Product hierarchy no. *			Part no.	SBU	Type / Description	Customer part no.
SBU PG	PGU	Type				
02	007	002	0000002028	See list below	Appliance Inlet 10A 70°	6100-3

2 Type of change

6100-3					0118.2299	
creation date	created by	release date	released by	notification no.	revision	page
2015-07-24	hollenpe	2015-08-18	hollenpe		a	1 of 1

Old product appearance	New product appearance

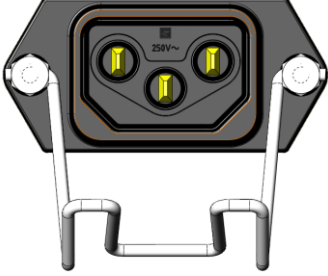
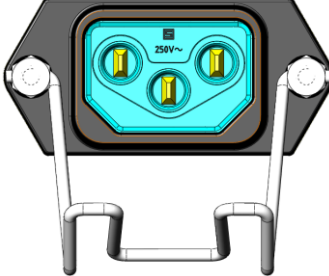
New colour of inlet gasket. Old gasket with black colour, new gasket in blue.

Better visualization of the IP 54 protection of cord connection for 6100-3 with inlet gasket. Safer and easier identification for the end user.
